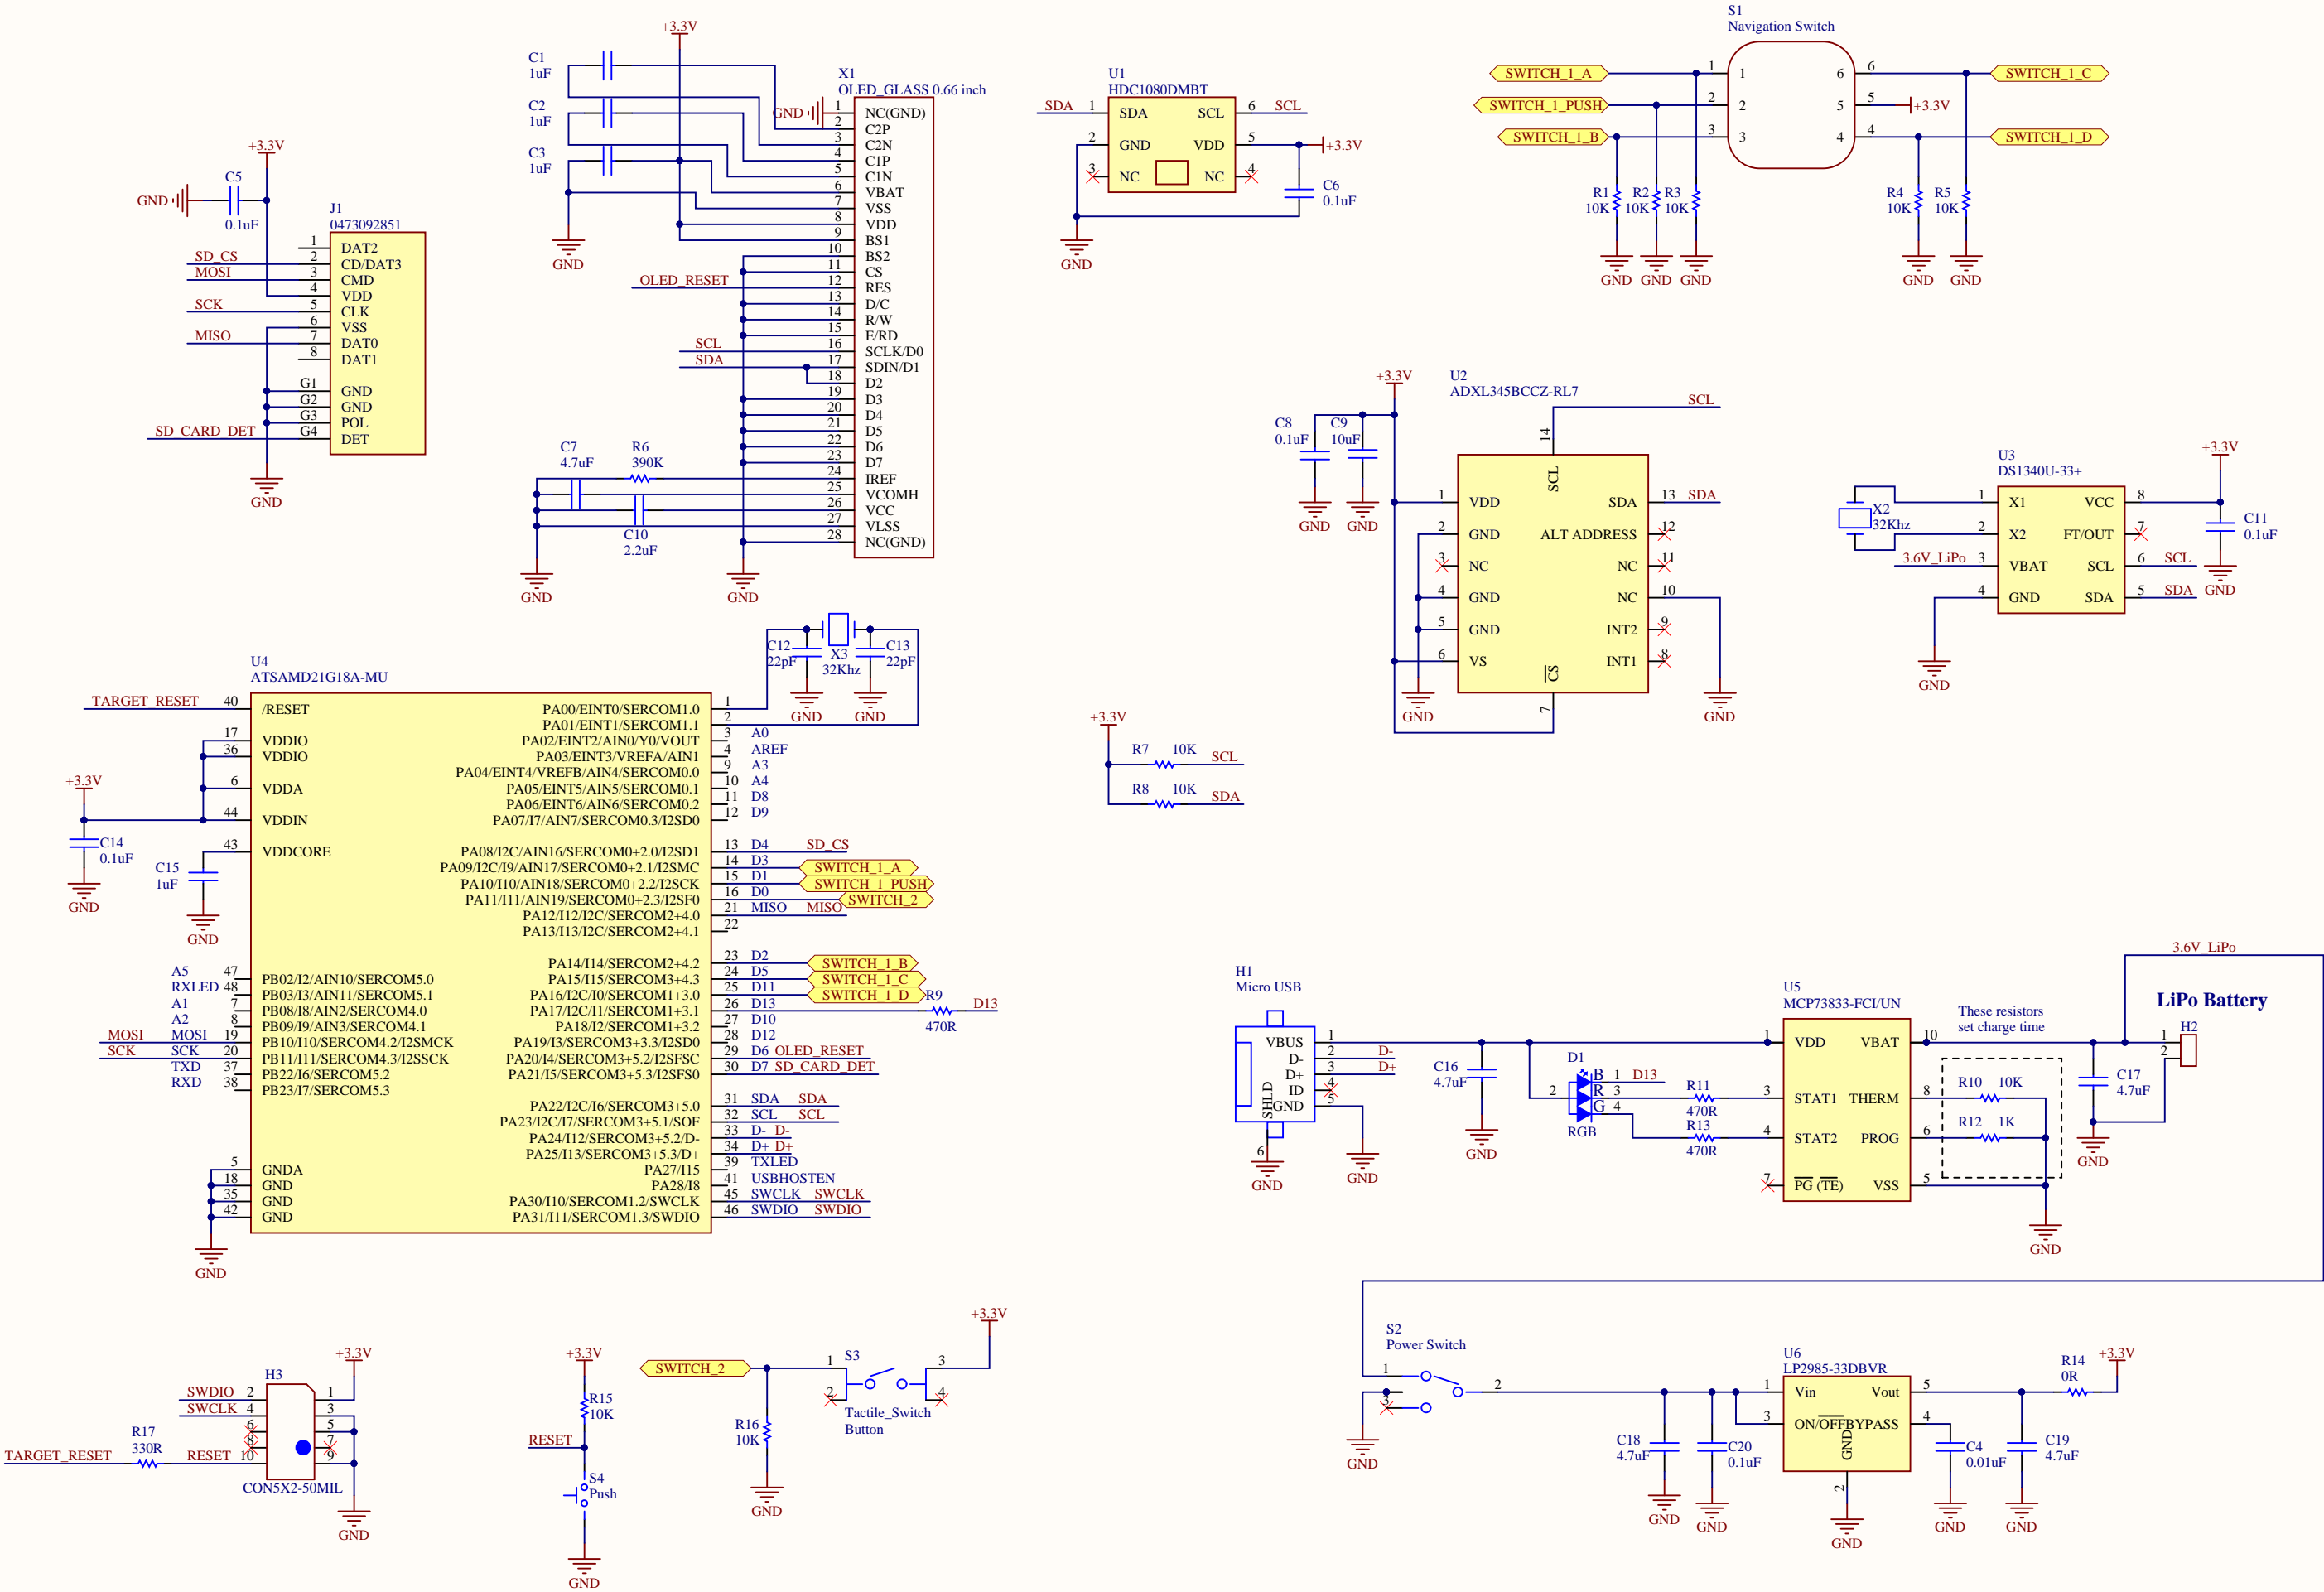
Fix on next Revision
Missing + & - on LiPo connector
Need a stronger LDO (use CAT6219-330TDGT3)
Thicker tracks, remove pin 7 from Segger con
Three individual leds, one res network
Remove accel, adjust oled solder con position
